Arlington High School Building Committee

Meeting Materials Package – 5/3/2022

Change Order (CO)

Items included in this Change Order:	Cost:
CR 093.1 RFI 216.2 Provide Fire-rated ceiling at Stair 1 for elec conduit.	\$ 4,348.03
CR 189R1 ASI-112-112.1 Misc steel and conc changes Bldg B.	\$ 8,833.05
CR 203R2 ASI-121 Chase wall revisions abutting locker pods Bldg B.	\$ 35,810.78
CR 222 ASI-137-137.1RCP Revs- added GWB soffit at Part E.	\$ 2,045.99
CR 266 CCD-031-ASI-163 provide Spandrel glass in lieu of clear at CW52.	\$ 4,337.64
CR 291 ASI-176 Plywd barrier at catwalk gap between perimeter wall.	\$ 7,408.41
CR 292 ASI-180 Provide milwrk cover of steel box-beam at Aud. Balcony.	\$ 4,903.99
CR 302 Provide steel angle for CW doors/sidelights support at foundation.	\$ 6,435.28
CR 306 Rev to ceiling at Guidance area- added ceiling trim-soffit condition	\$ 3,752.54
CR 320 RFI-392 Rev GWB condition at CW49 for modified CW to wall relationship.	\$ 3,613.26
CR 323.1 RFI-582 Provide Boiler EPO Switches PH 2 areas.	\$ 3,712.59

ARLINGTON HIGH SCHOOL
Massachusetts Avenue, Arlington, Massachusetts
**Revisions to Section 1/S6.2.9 - Revised Relieving Angle
Elevation**

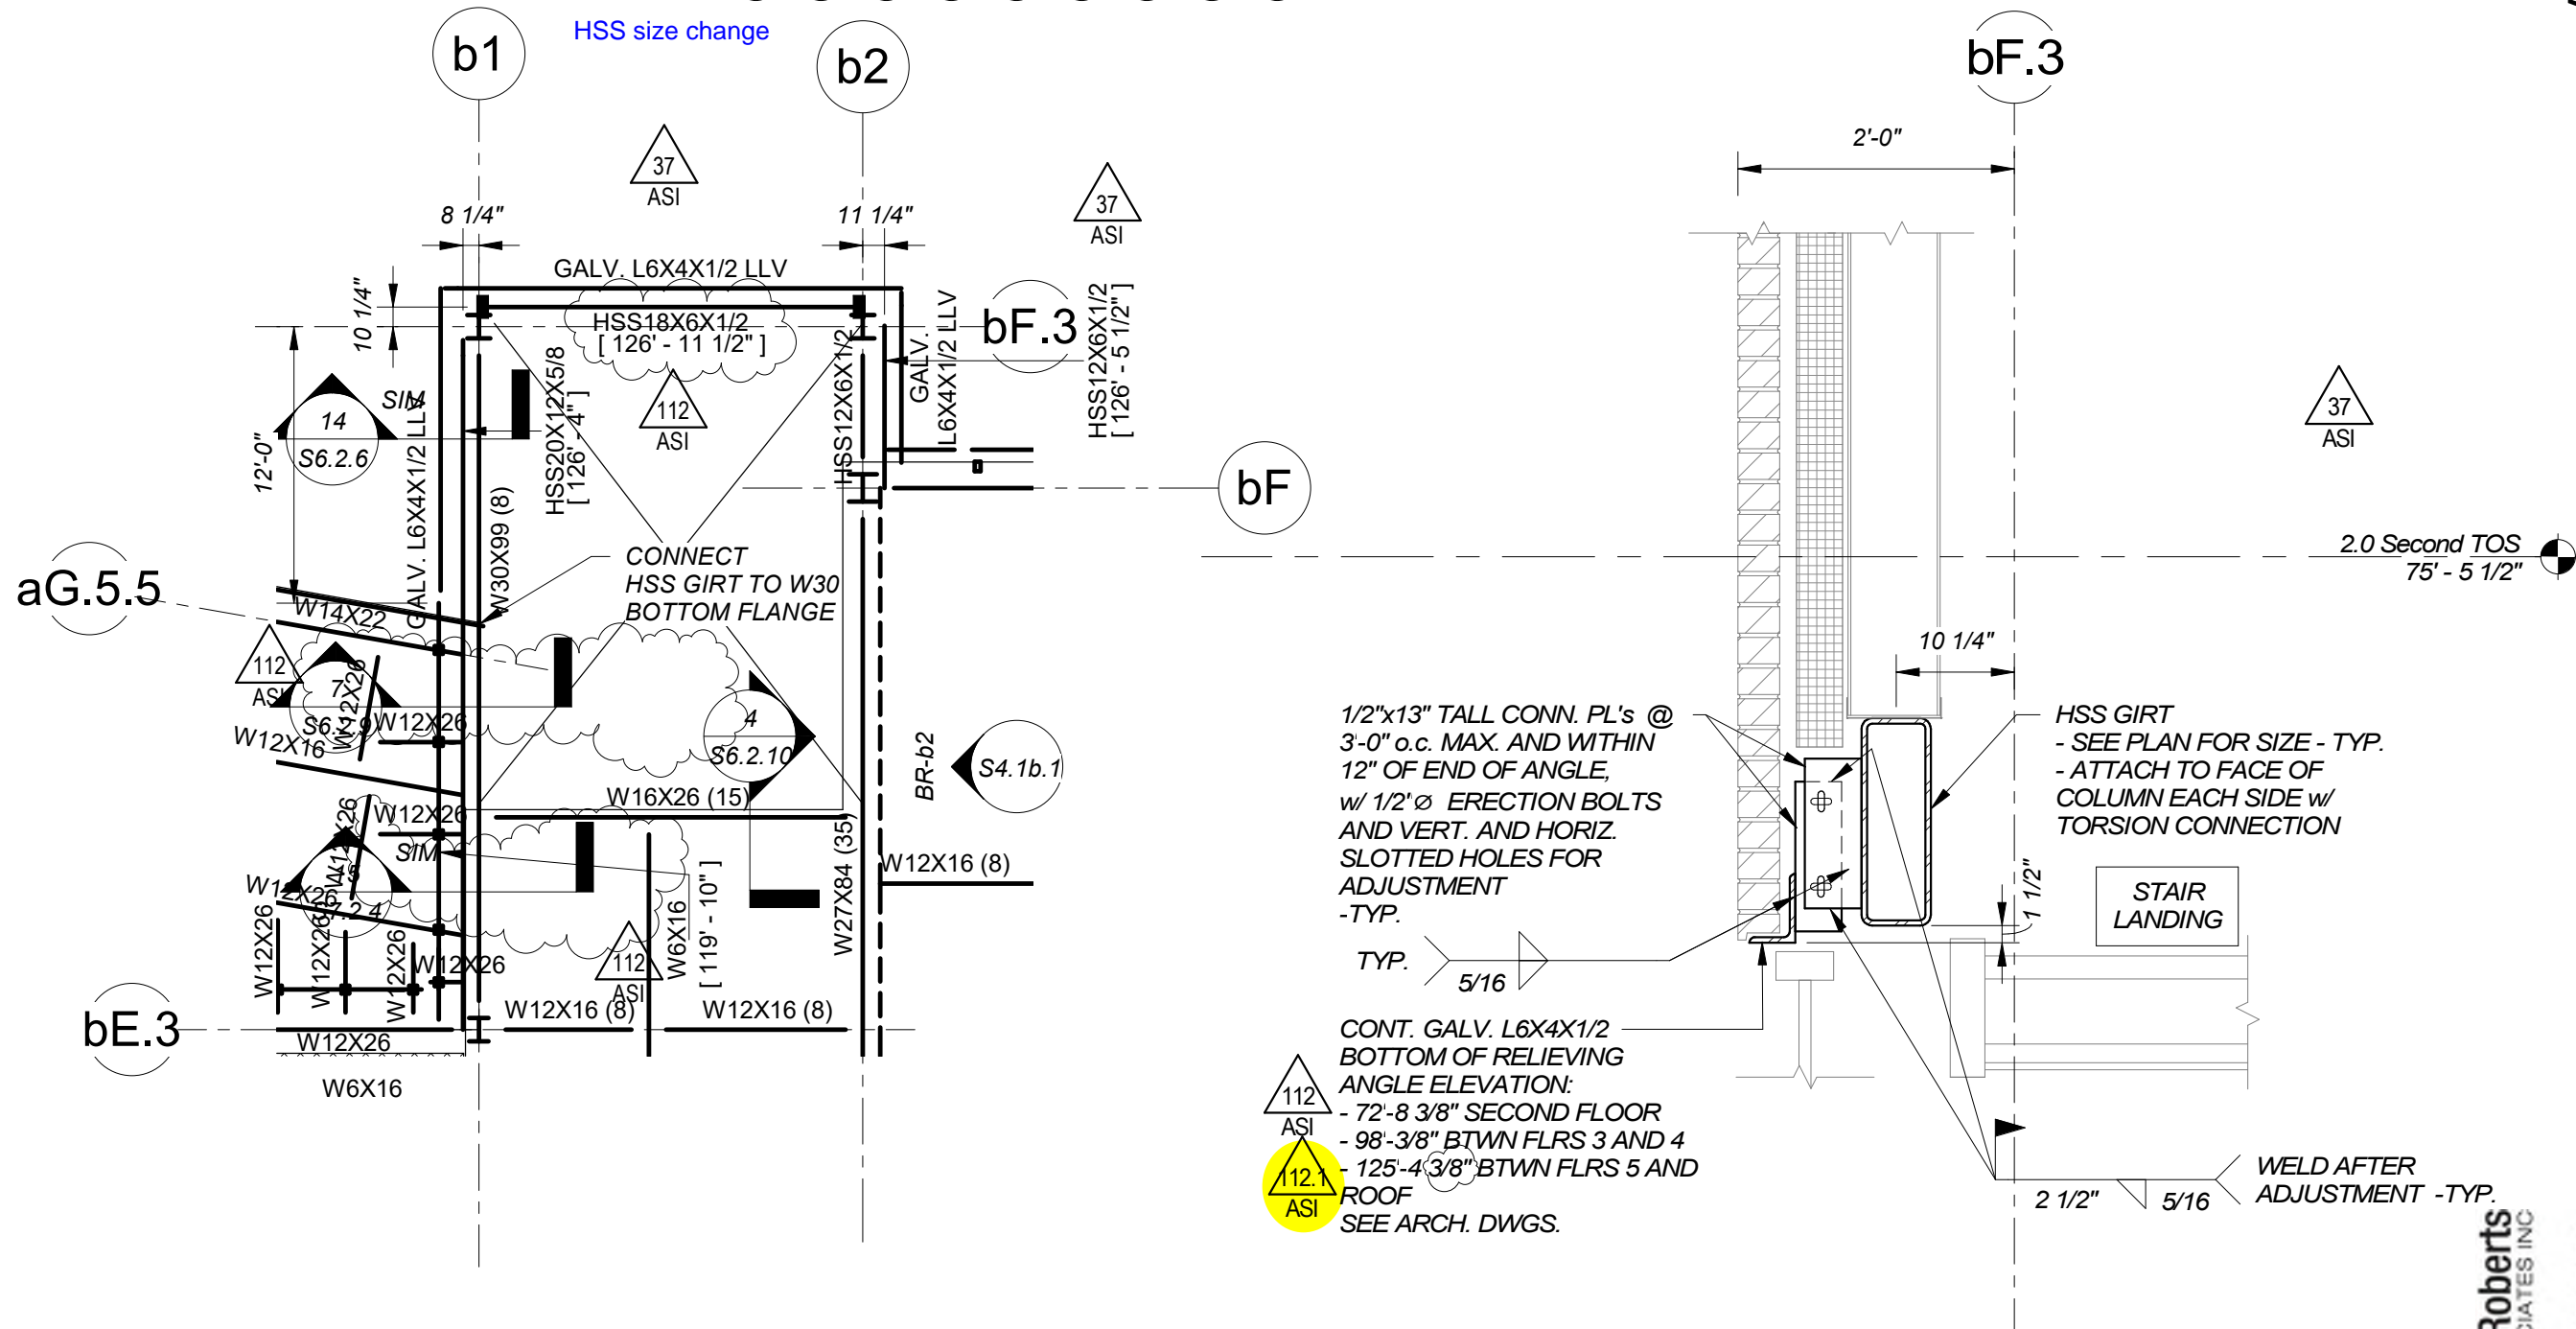
Miscellaneous steel and concrete changes Part b
Revised sketch SKS-146R1- dimension (elevation) revision

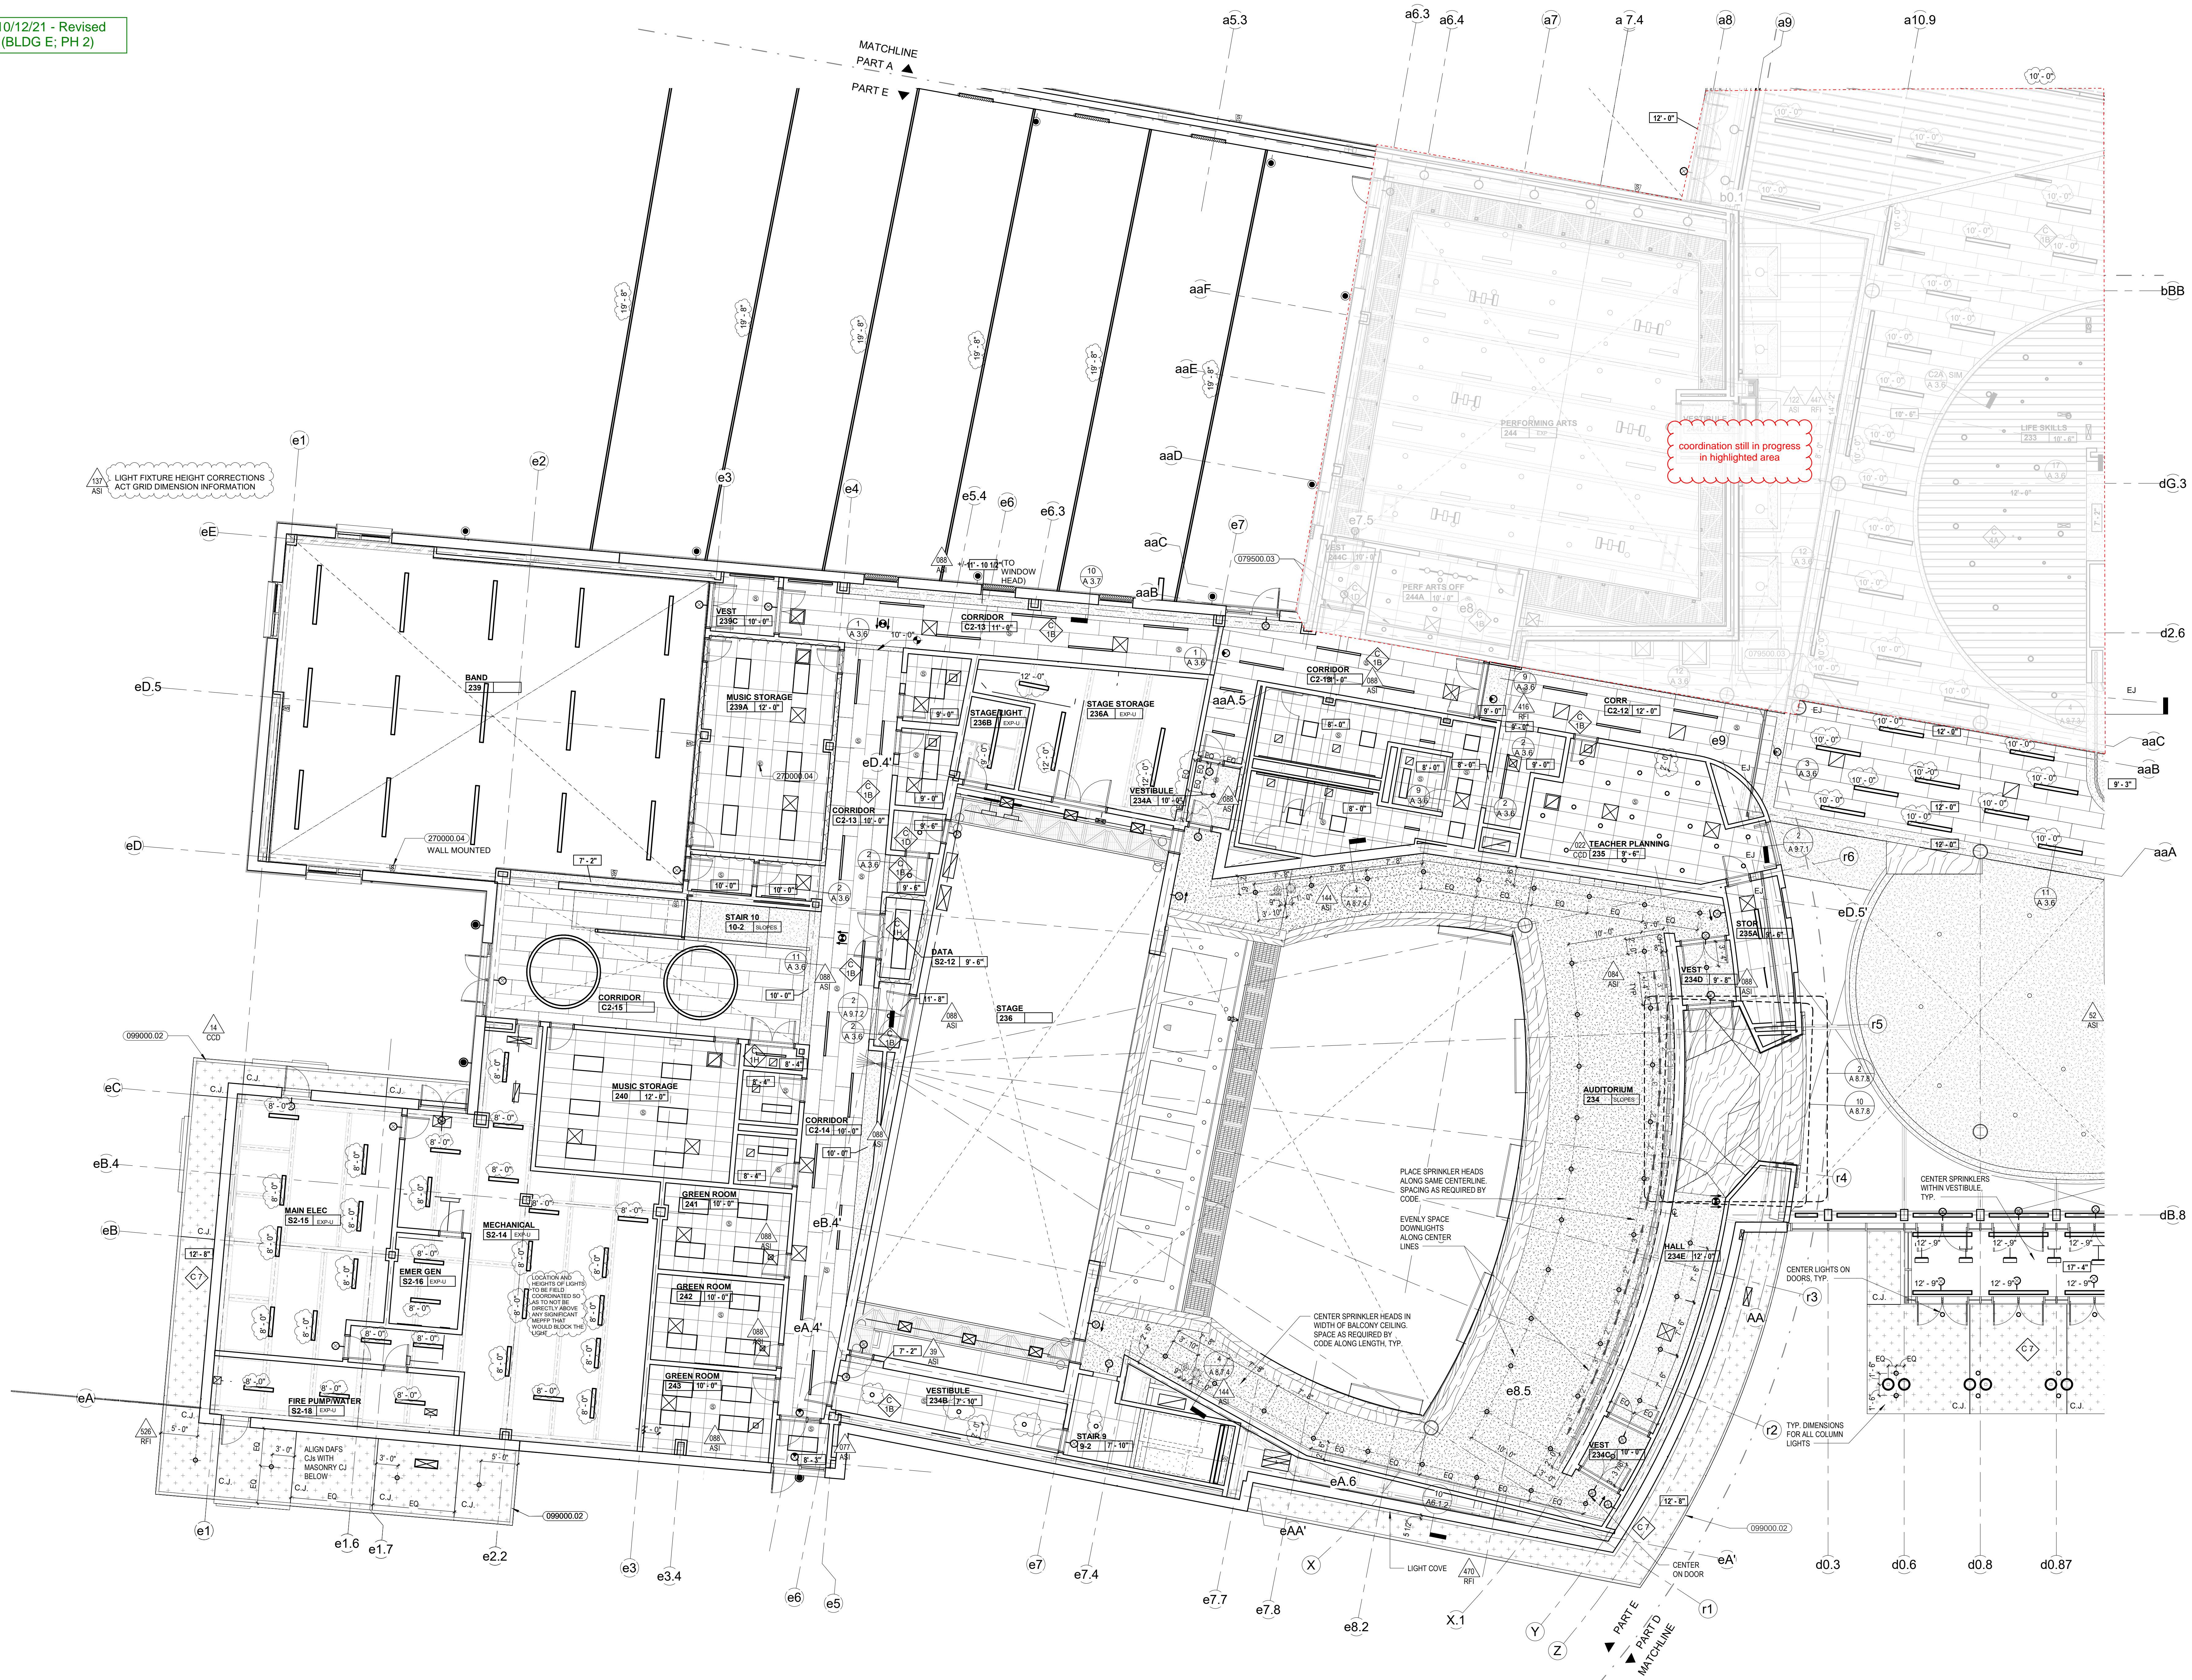
- Heights of pendant light fixtures have been corrected / clouded on the RCP
- Undercabinet light fixtures which were erroneously displayed on the RCP have been hidden.
- Light fixture locations adjusted as part of the coordination process have been clouded

- TYPICAL: Linear diffusers at all classrooms are to be located within the last full tile along the grid line at the exterior edge of the room.
 - o Diffusers in some rooms located differently where conflicts with ductwork/steel were anticipated.
- Diffusers within rooms have been adjusted accordingly to reflect their locations on the coordination drawings.

REF. DWG. E2.0b RFI-582

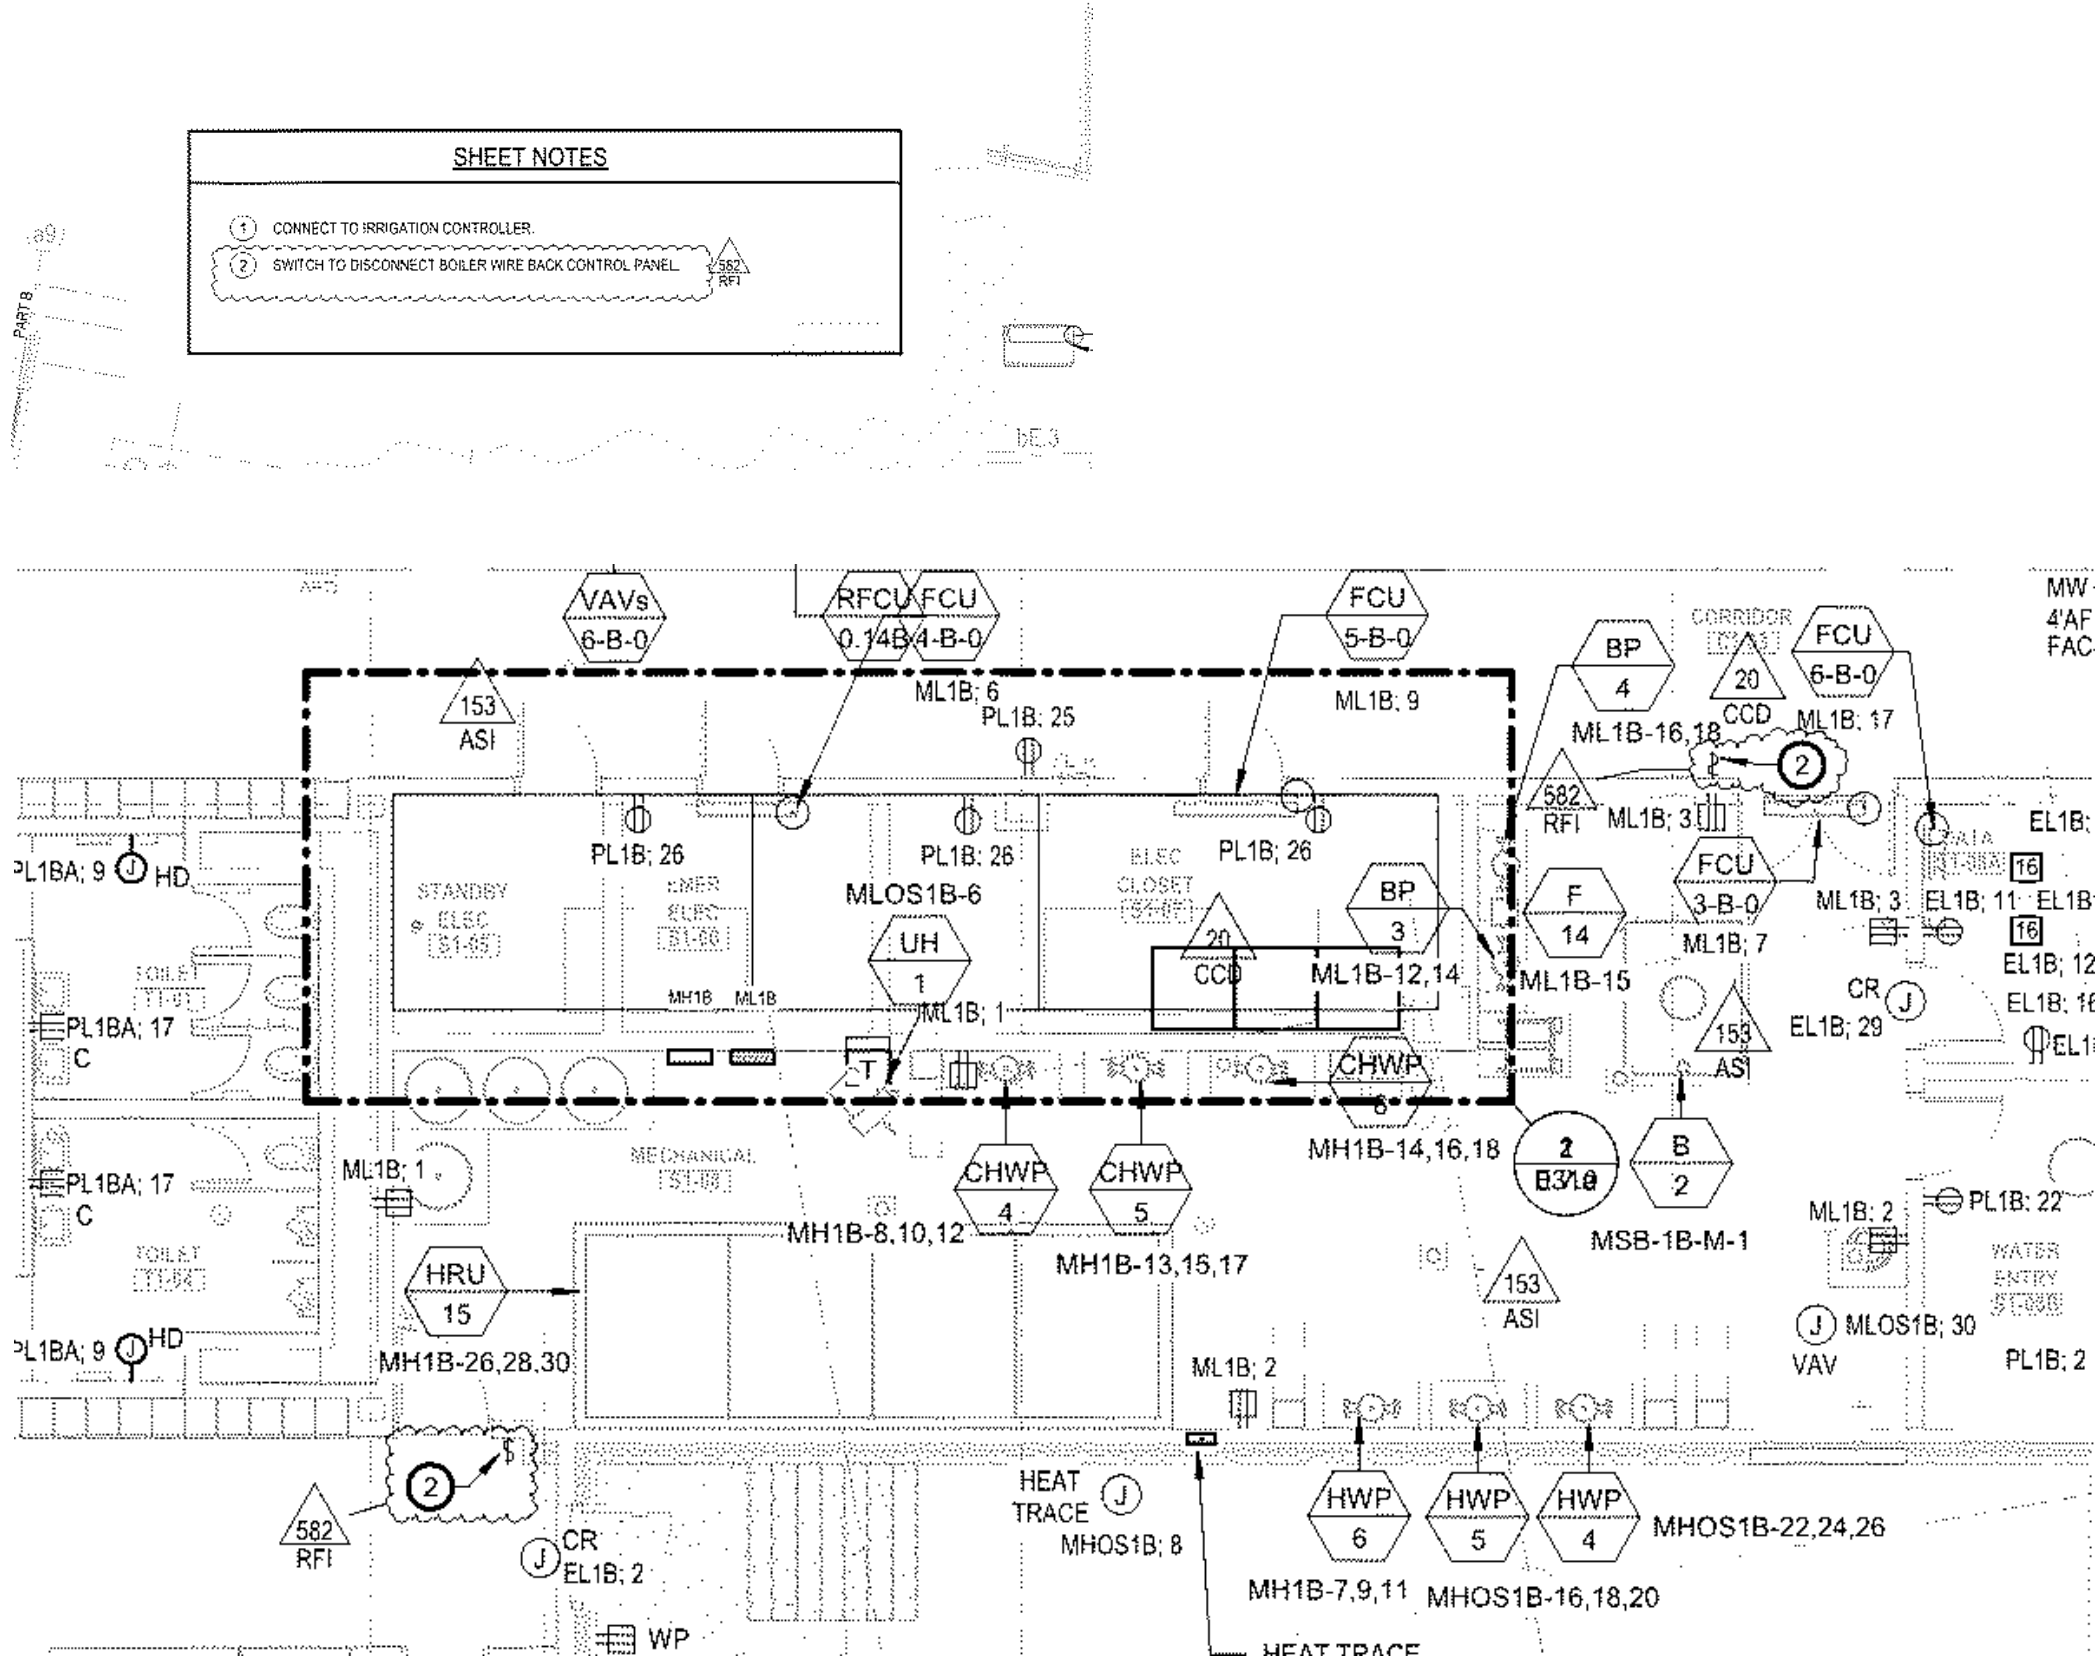
The switch at Corridor C2-15 is to be located centered within the width of tile between doors S2-14 and 240.2.
